CHANGES ARE MADE IN DETERMINATIONS OF BASE FLOOD ELEVATIONS FOR THE CITY OF ALBUQUERQUE, BERNALILLO COUNTY, NEW MEXICO UNDER THE NATIONAL FLOOD INSURANCE PROGRAM

FIRM
FLOOD INSURANCE RATE MAP
 BERNALILLO COUNTY,
 NEW MEXICO AND
 INCORPORATED AREAS

**Re: Submittal of Requested Information
 Request for Letter of Map Revision
 HomeBase at Towne Park Plaza
 Albuquerque, New Mexico
 Zia Project No. Z00-003**

Community: City of Albuquerque, NM
Community No.: 350002
Panels Affected: 35001C0358 D and 0359 D
Effective Date of **JUL 13 2000**
This Revision:

MAP NUMBER
 3500TC0359 D

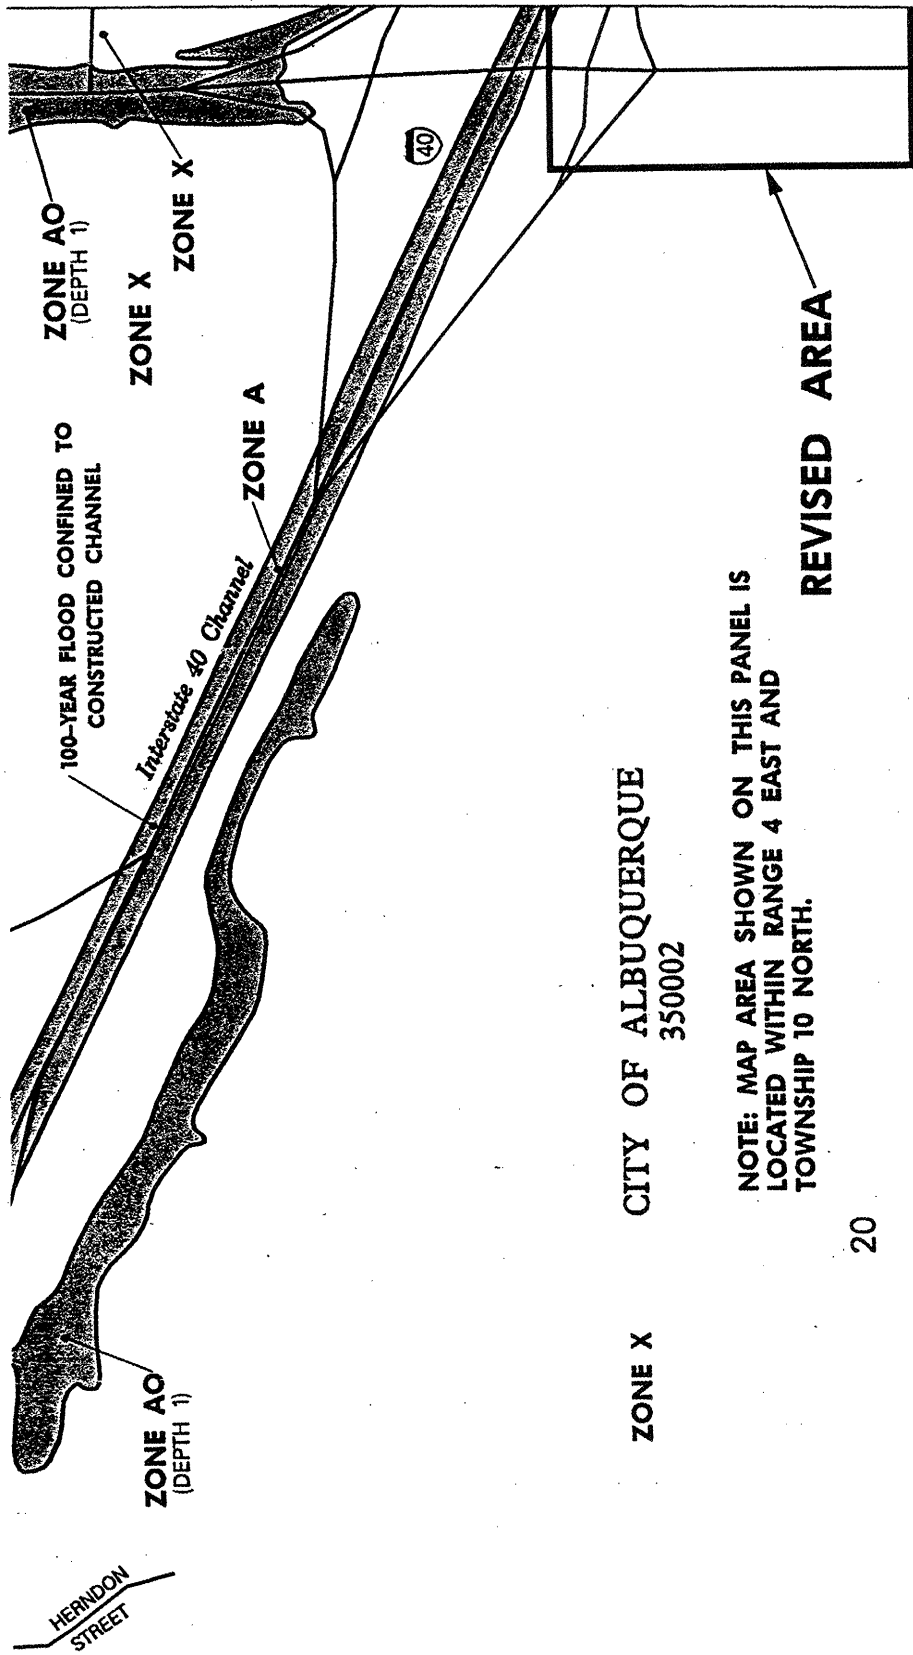
Hydrologic and hydraulic analyses were performed to incorporate the effects of placement of fill and grading associated with construction of HomeBase at Towne Park Plaza southeast of the intersection of Interstate Highway 40 and Eubank Boulevard and construction of a 48-inch-diameter culvert beneath Interstate Highway 40 approximately 1,020 feet east of Eubank Boulevard. This has resulted in a decrease in SFHA width for an approximately 500-foot-long by 400-foot-wide L-shaped area southeast of the intersection of Eubank Boulevard and Interstate Highway 40. A BFE was established for the SFHA located between approximately 250 feet east and approximately 500 feet east of Eubank Boulevard and between approximately 200 feet south and approximately 100 feet south of Interstate Highway 40. The aforementioned culvert contains the base flood that originates from the area east of the HomeBase development. The table below indicates existing and modified BFEs for selected locations cited above.

Location	Existing BFE (feet)*	Modified BFE (feet)*
Area located between approximately 250 feet east and approximately 500 feet east of Eubank Boulevard and between approximately 200 feet south and approximately 100 feet south of Interstate Highway 40	None	5,437

RETAINING WALL AND
GRADING DETAILS

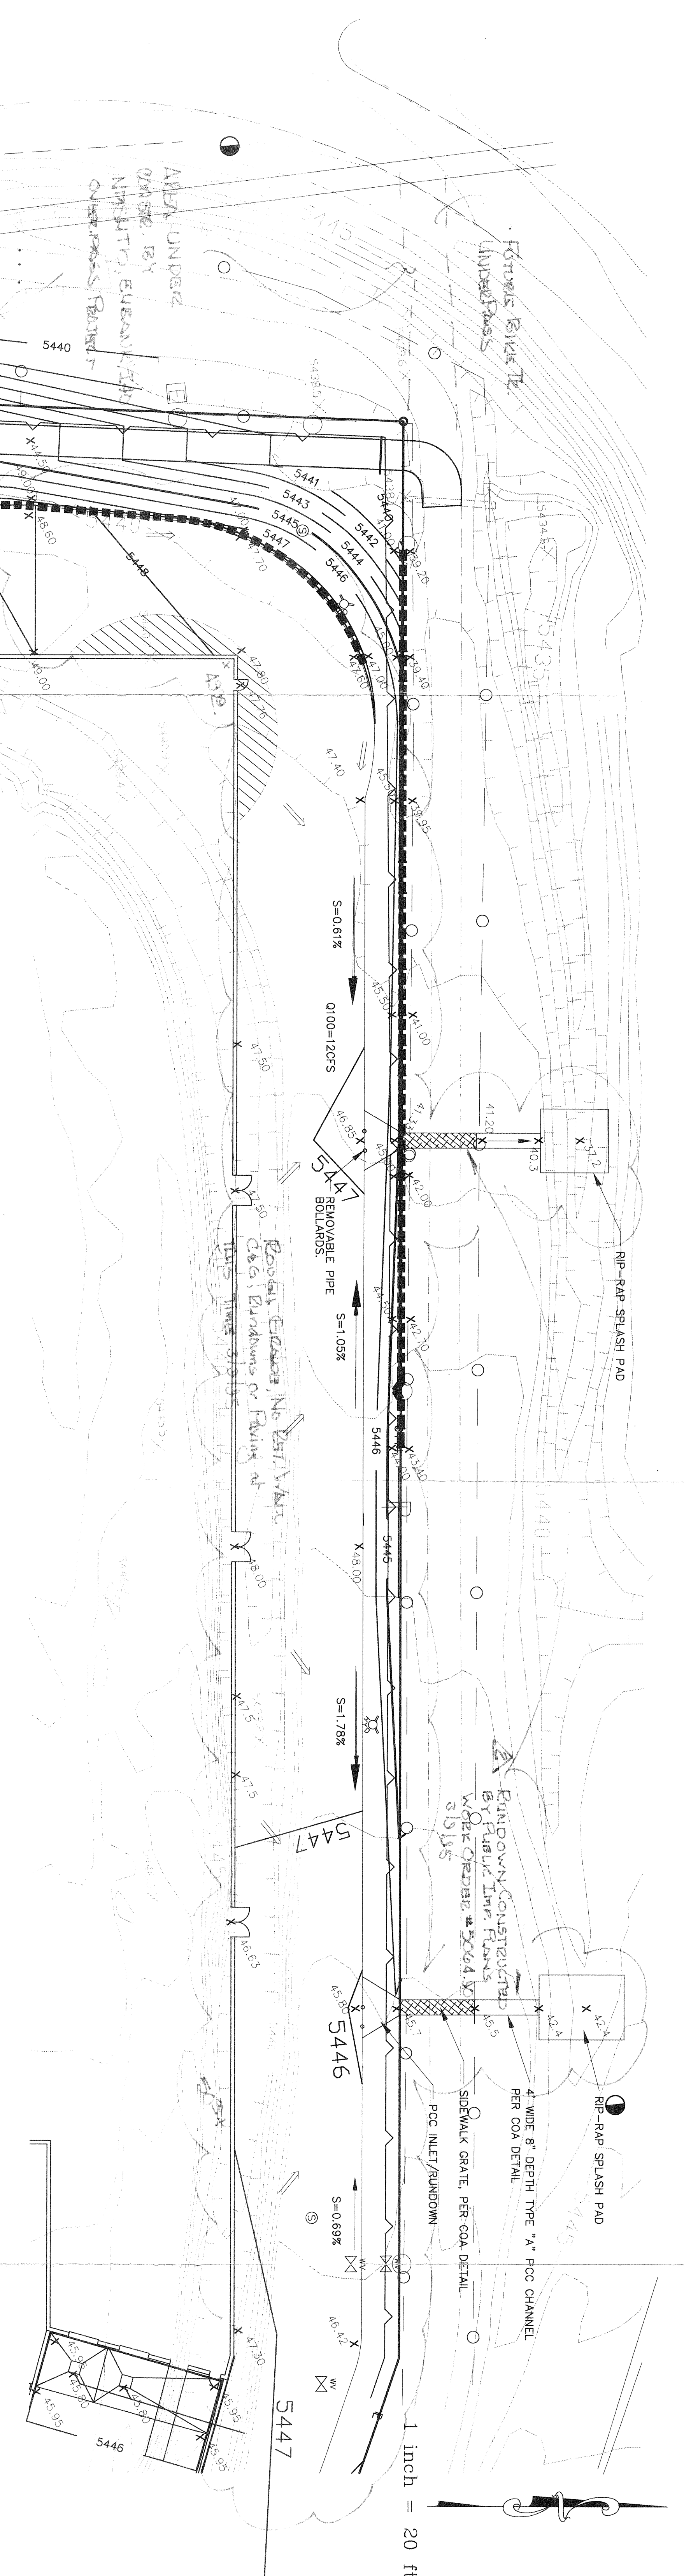
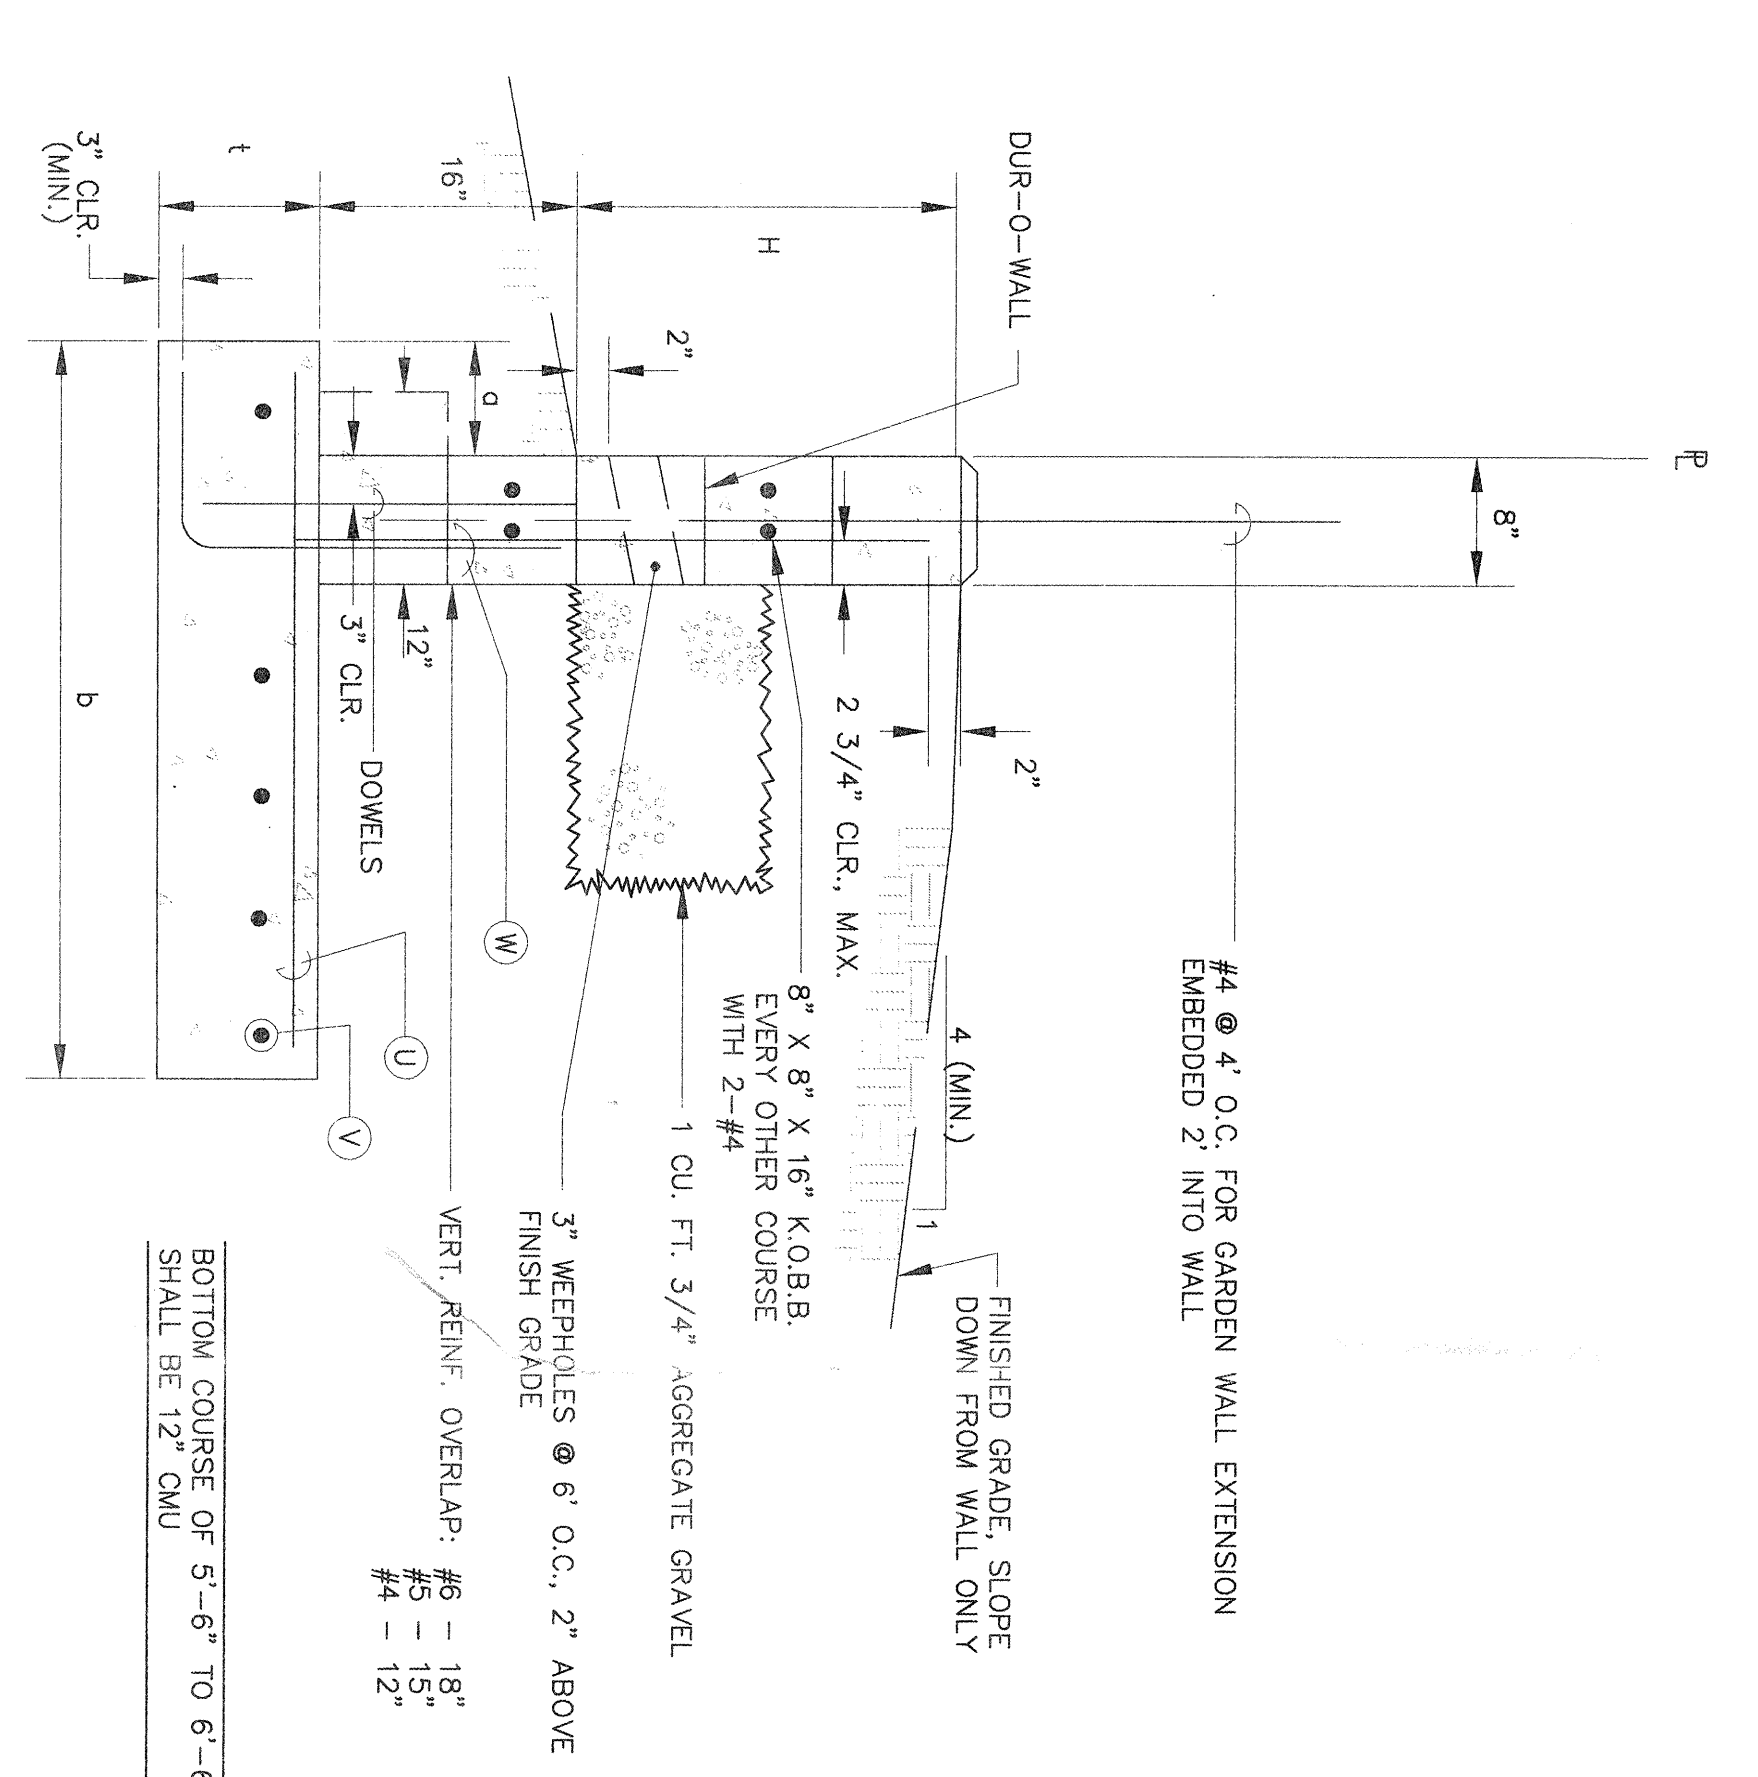
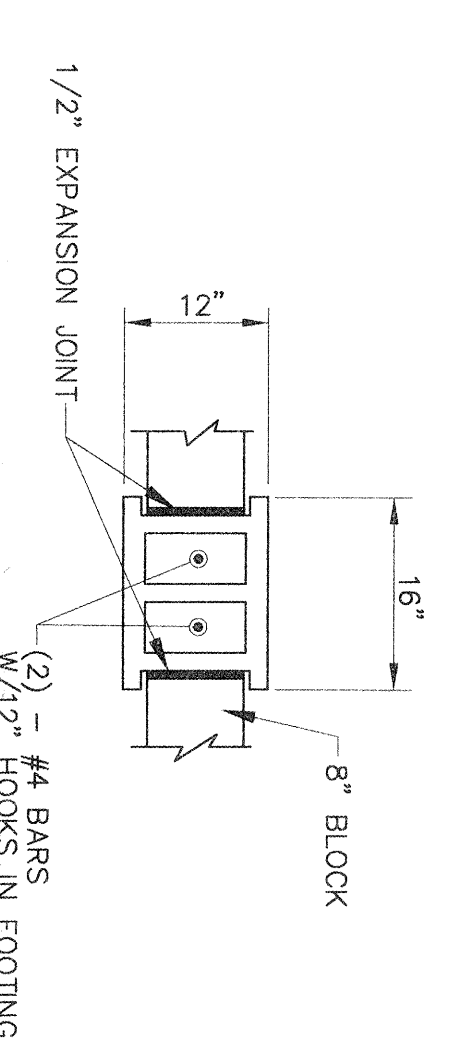
I, Rick Behrman, a professional engineer of New Mexico, having conducted a site inspection with as-built survey information made available by the project surveyor (MHP's 874121), certify that the site grading and drainage improvements are complete and substantially comply with the approved drainage report and construction plans.
